From: John Stafsholt <jstafsholt@aps-tech.com>
Sent: Sunday, July 10, 2016 9:02 AM
To: Adam Strachan; Laura Suesser; Melissa Band; Douglas Thimm; John Phillips; Preston Campbell; Steve Joyce
Cc: Francisco Astorga; Bruce Erickson; Treasure Comments
Subject: Public Input Letter for Treasure Hill Meeting 7/13/16 and beyond
Attachments: Treasure Vested Density V1 7-13-2016.pdf

This letter is to address the Treasure Hill vested MPD densities for the Mid-station & Creole Gulch parcels. This is also the first letter that I have written since 2010, so I think that there are a few general points that should be brought up first.

Treasure Hill Size, Mass, Scale & Density

1. Approved Density Hillside Properties (pg 8) (Dated 12/18/1985)

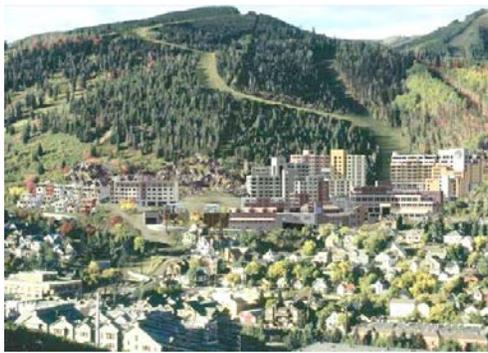
A) Please note: This is the original document which gives a density of 197 X 2,000=394,000 residential & 19 X 1,000=19,000 support commercial for a total maximum of 413,000 sq ft.

No comprehensive document exists showing the density transfers between all the previous built parcels over the years, so the real sq ft may certainly be less than 413,000.

B) Please note: Almost all of the Hillside density comes from 15 acres of HR1 zoned properties. It is very important to note that all the Mid-station and Creole Gulch underlying zoning is in the historic zone either HR1 or Estate.

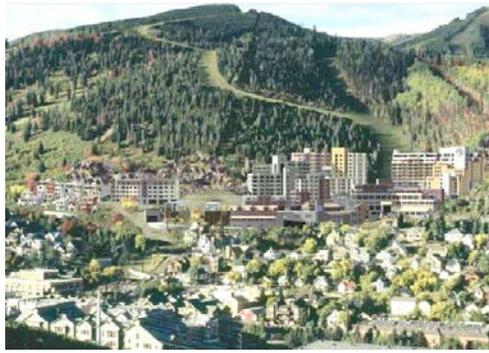
- C) Located in the Historic District, this project must be compatible with the scale already established & sensitive to the surrounding neighborhood. The Hillside project is not in any way compatible nor does it show any sensitivity to the district. Just look at the pictures.

3. Creole Gulch Maximum height reduced to 75 ft (pg 5)

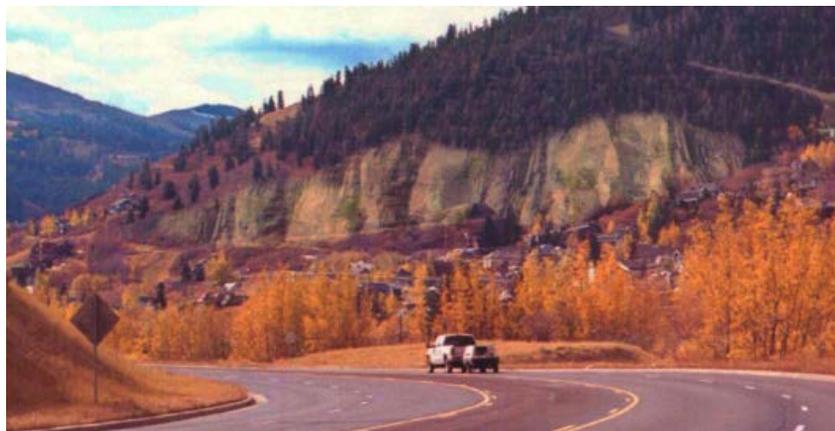
- A) Creole Gulch's original permitted height was 28ft HR-1. MPE requested 95ft and council lowered it to 75ft. This is a maximum building height, period. It is not from either existing grade or final grade. It is not from downhill or uphill. It is the height of the building from the basement to the roof.

If you excavate 100ft vertical and leave a scar for a 137' building. That building is not 37ft.

- B) The council understood the excavation/backfill methods used by developers to game the approval and add significant height. That is why the council added elevations of 7,250' & 7,275' above mean sea level.

- B) Average overall height calculations of less than 45ft are wildly inaccurate. Staff should request these calculations.
- C) Massing issues exist with most bldgs, but especially:
Bldg 5A: 11 stories 150' tall & 60,000 sq ft w/ 39% circulation, common space, & accessory
Bldg 5C: 12 stories 145' tall & 81,000 sq ft w/ 37% circulation, etc...
Bldg 4B: 13 stories 137' tall & 252,000 sq ft w/37% circulation, etc...

- D) The overriding design features on the site are building positioning and orientation to allow for extreme heights through excavation of the existing hillsides. This excavation is proposed at unprecedented volumes and is massively destructive. CUP 15 will address this in the future. But, every tree goes down. The entire 11.5acre site is leveled, then excavated for connecting roads & multiple parking levels. Vertical scars 100ft or more, erosion problems, nowhere to remove toxic soil. Toxic soils from 4 mines can't be disturbed and then expected to be left on site.
